APPENDIX D

Agency Correspondence

Appendix B-4— Updated Receptor Grid Maps

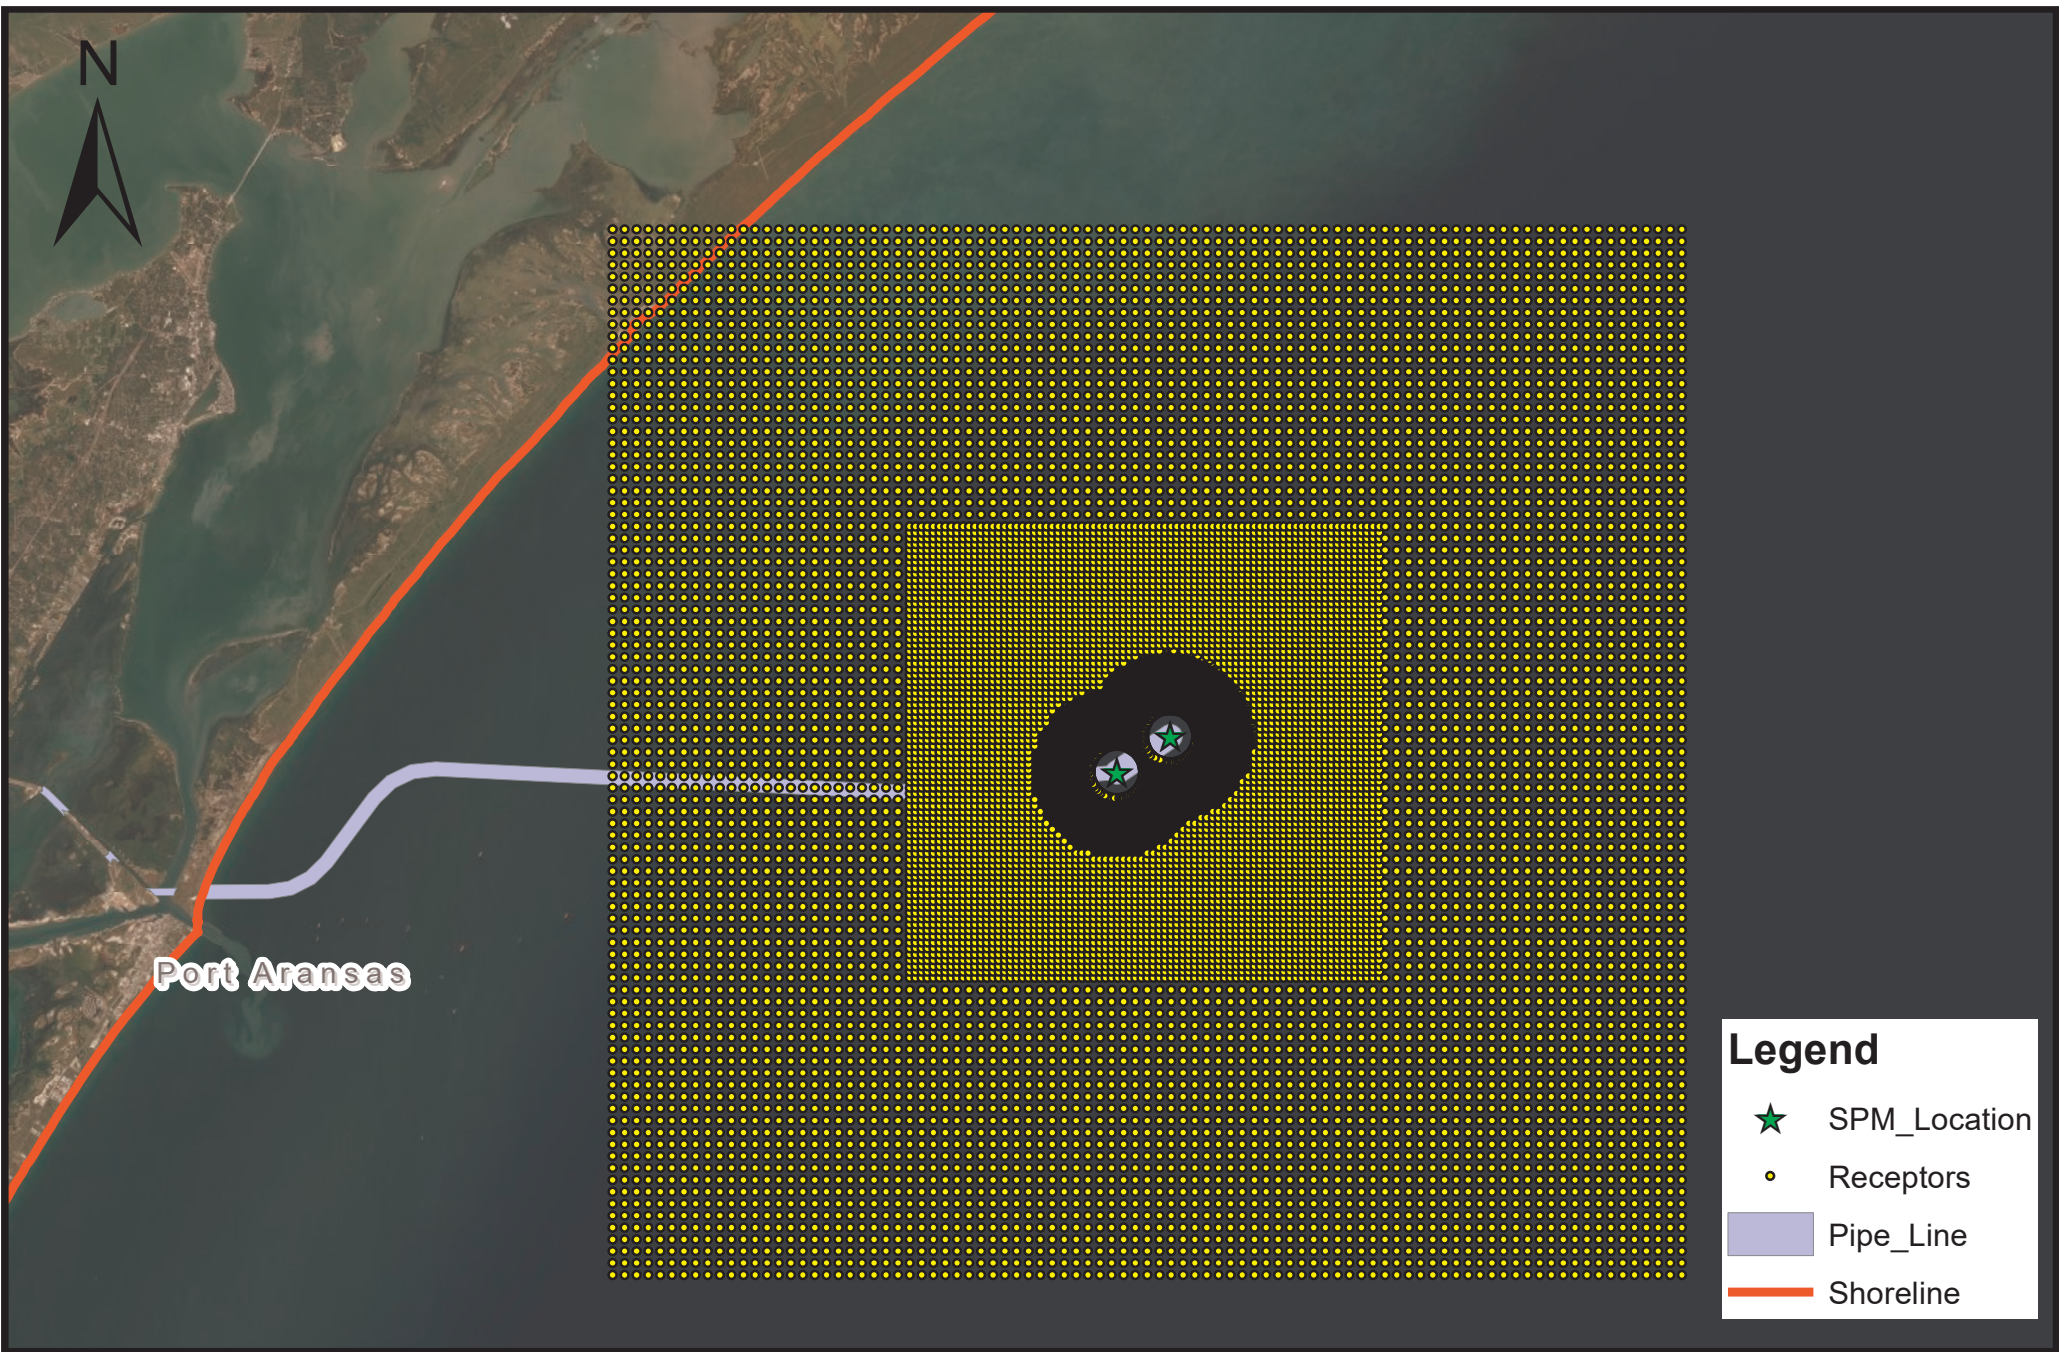
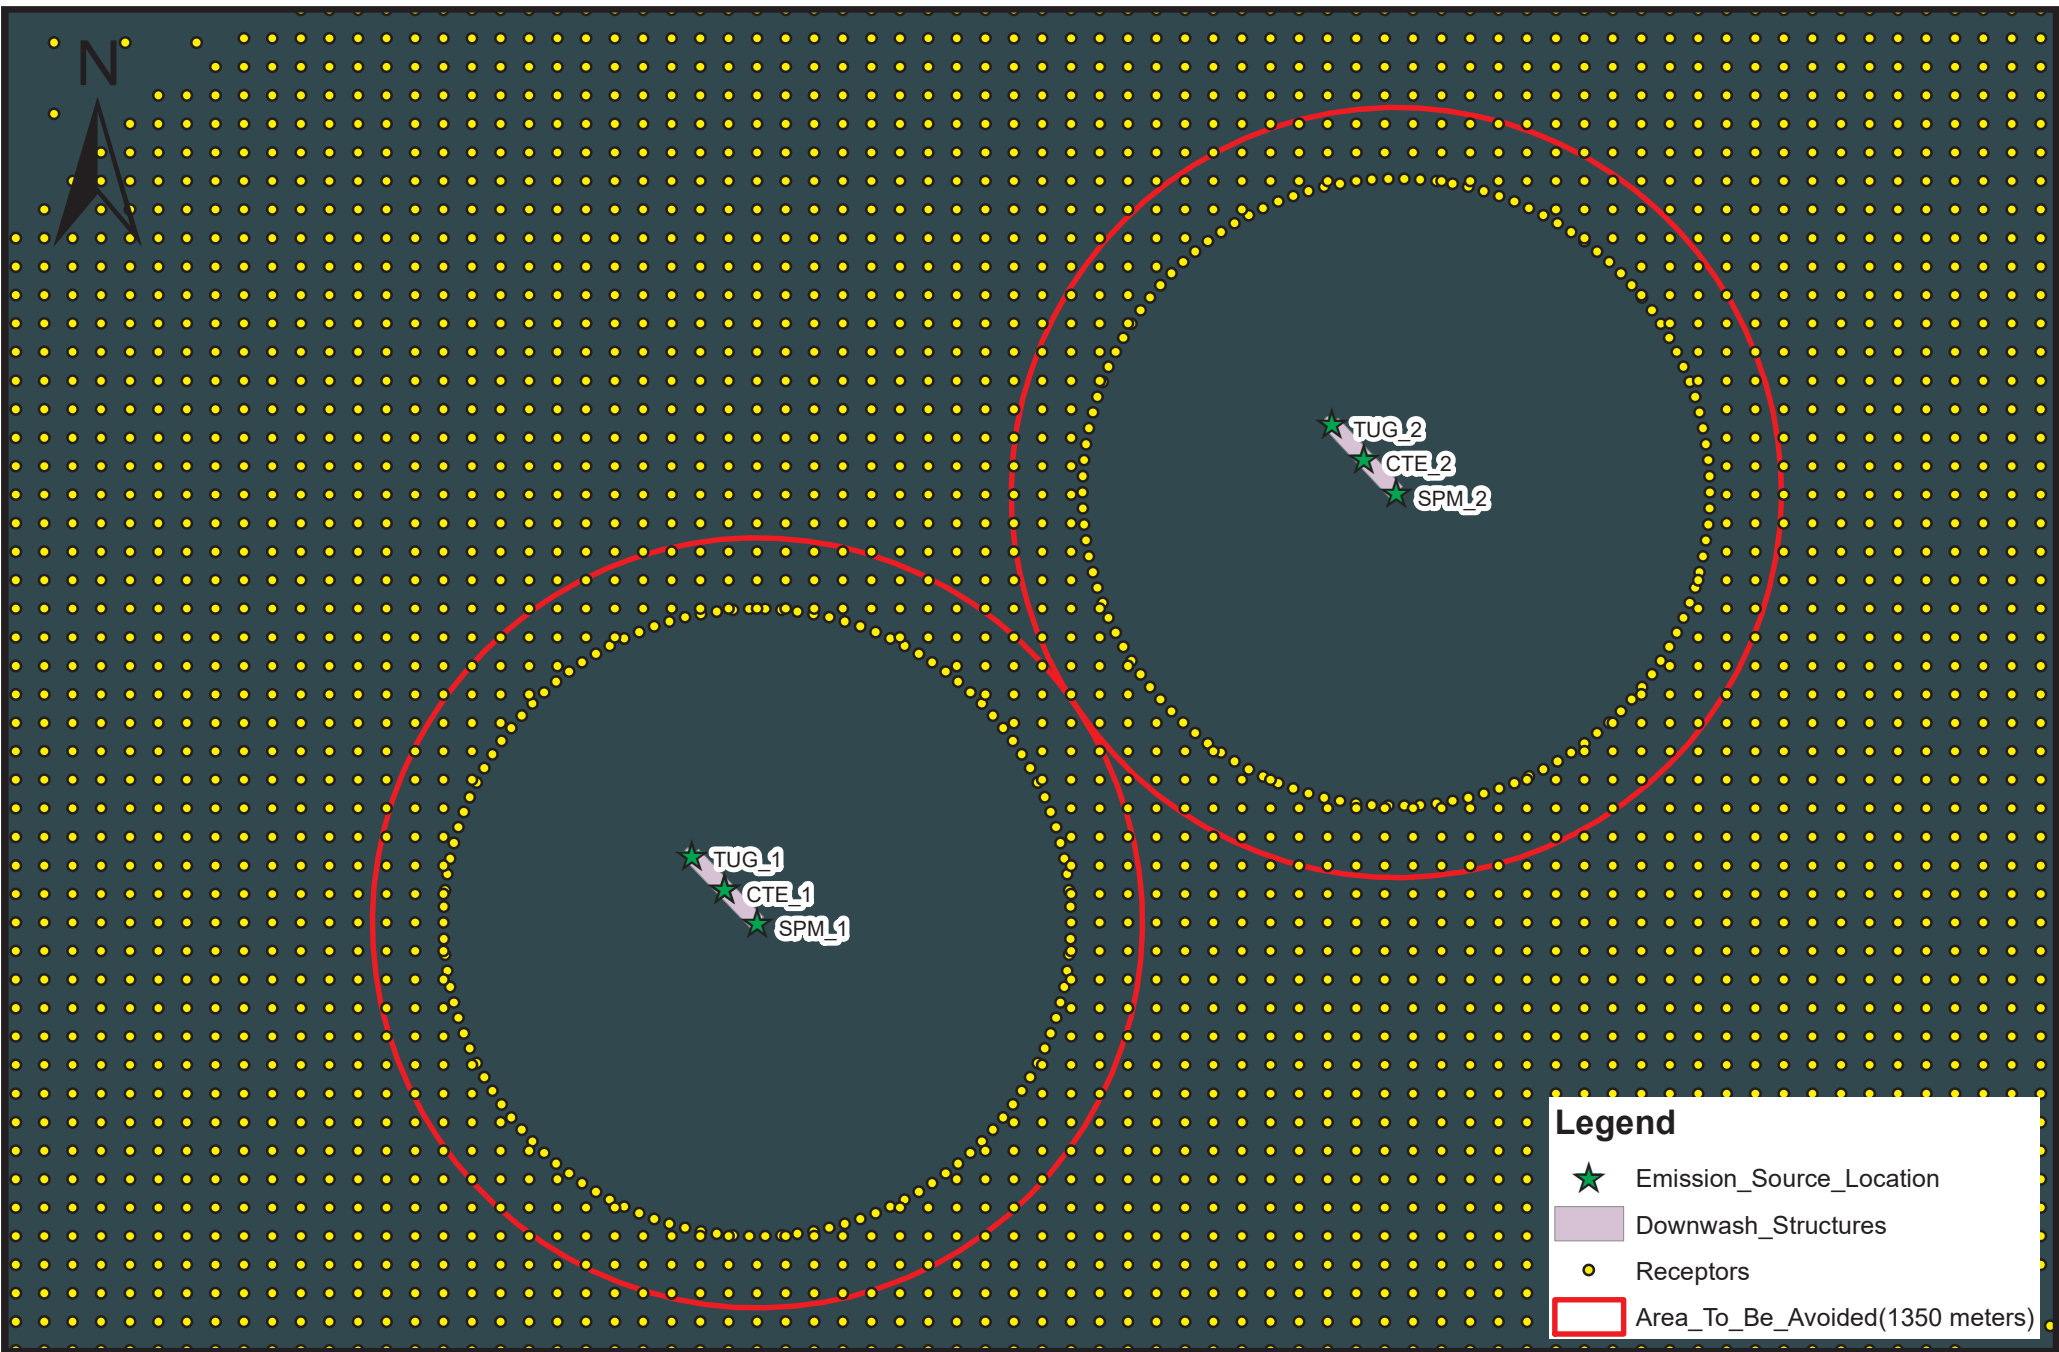
- 14) Section 3.7 of the Air Dispersion Modeling Report indicates that the receptor grid data was developed based on each of the single point mooring systems being surrounded by a circular “safety zone” and an additional circular “area to be avoided” making a composite circular boundary with radius of 1,350 meters around each of the central buoys. Please provide additional information regarding the difference between these areas, including what if any access the public may have within the areas. This information is necessary to determine if the ambient air has been appropriately represented within the modeling analysis.

Figure 1— Depiction of Option 3

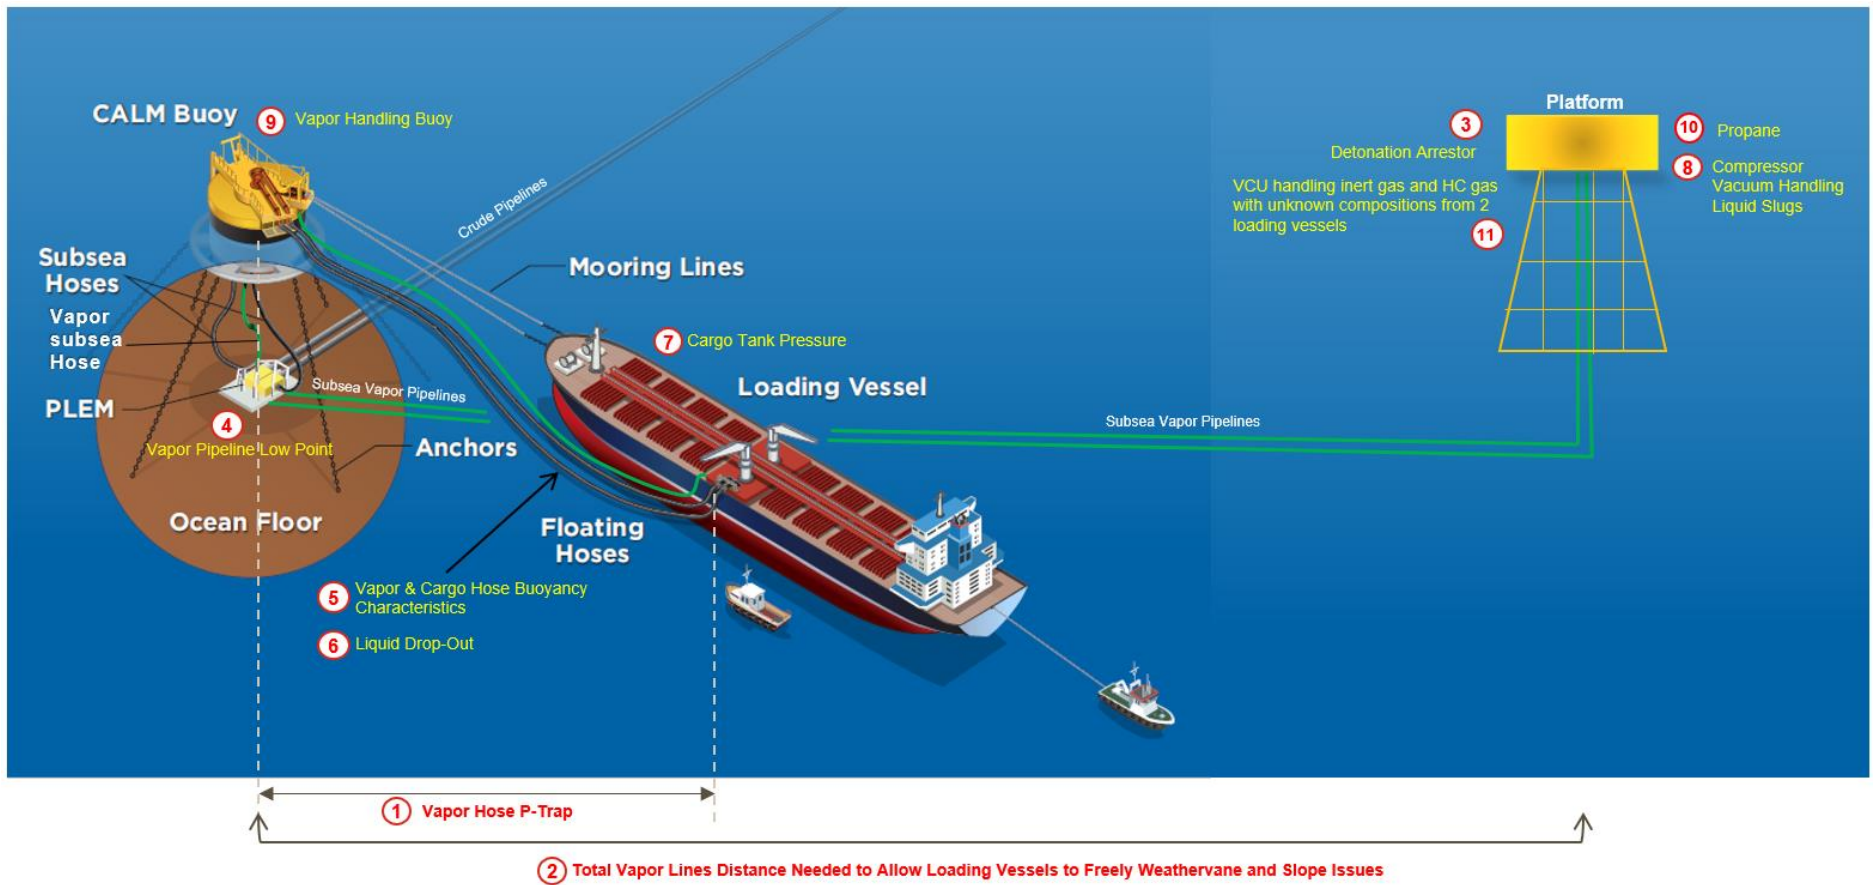
Option 3 consists of modifications to the CALM buoy-based² marine loading facility as shown in Figure 1 (below): First, the floating product transfer hose is accompanied by a floating vapor recovery hose which conveys loading vapors from the loaded tanker back to the CALM buoy. Second, the CALM buoy is modified to accept a connection from the floating vapor hose. Third, an additional under-buoy vapor hose carries loading vapors from the modified CALM buoy to the pipeline end manifold (PLEM), which is also modified to accept incoming vapors. Fourth, a pair of vapor pipelines are constructed which run along the seabed from the PLEM to the base of an offshore platform; Fifth, an offshore platform is constructed; Sixth, a vapor riser (i.e., vertical pipeline) carries loading vapors from the subsea vapor pipeline to the platform deck. Seventh, a system consisting of one or more vapor combustors (VCUs), a dock safety skid, enrichment, inerting and fuel delivery facilities is constructed on the platform for destruction of VOC in the loading vapors. Eighth, pig traps are installed on the offshore platform to permit round-trip pigging of the paired subsea vapor pipelines, along with supplies of liquefied nitrogen to provide motive force for the pigs. Such a system for capturing and controlling VOC emissions in loading vapors has been described in a PSD permit application,³ and has been further analyzed in a separate case-by-case MACT application,⁴ but to BWTX's knowledge has not been constructed or demonstrated at any source.
